STAFF REPORT: 03-10-2021 REGULAR MEETING PREPARED BY: A. DYE APPLICATION NUMBER: 21-7125; 21-7129 & 21-7126 ADDRESS: 1031 MARLBOROUGH; 1039 MARLBOROUGH/1040 CHALMERS; 14501 E. JEFFERSON AVENUE HISTORIC DISTRICT: JEFFERSON-CHALMERS HISTORIC BUSINESS APPLICANT: MARQUES KING, JEFFERSON EAST DEVELOPMENT CORPORATION PROPERTY OWNER: JEFFERSON EAST DEVELOPMENT CORPORATION DATE OF PROVISIONALLY COMPLETE APPLICATION: 02-22-2021 DATE OF STAFF SITE VISIT: 01-29-21 & 02-26-21

SCOPE: REHABILITATION BUILDING; NEW SURFACE PARKING LOTs

1031 MARLBOROUGH

Google Street View Image, 2009

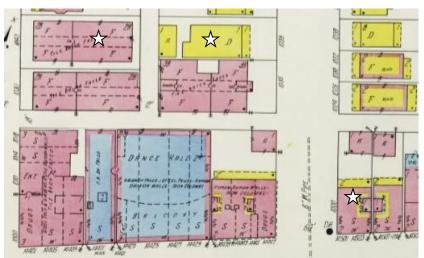
Staff does not have a designation photograph, however the adjacent Google street view image from August 2009 offers a fairly accurate representation of how the building must have looked at time of district designation (2008). Historic windows were present in the third floor front elevation openings, as well as the second and third floor stair landings. This image also clearly shows the brick covered front yard.

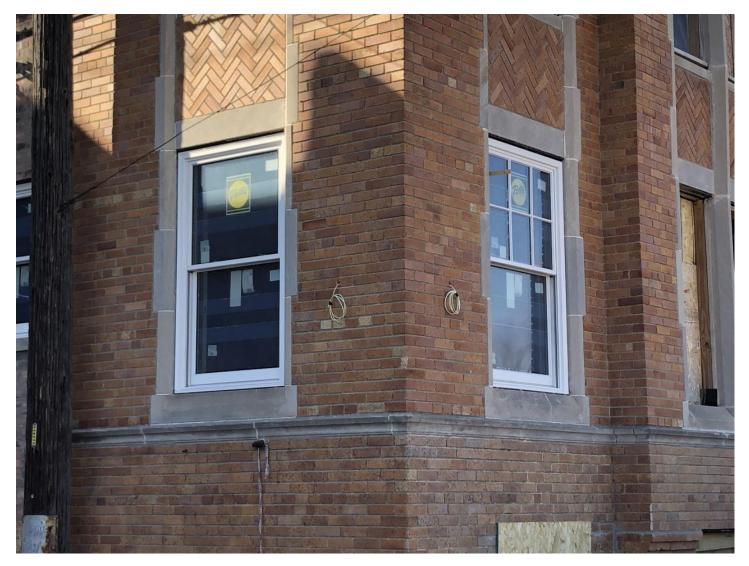
Double-Hung sash installed within the second floor landing should be eight-over-one.

The window on the left, staff believes, should have a six-over-one pattern.
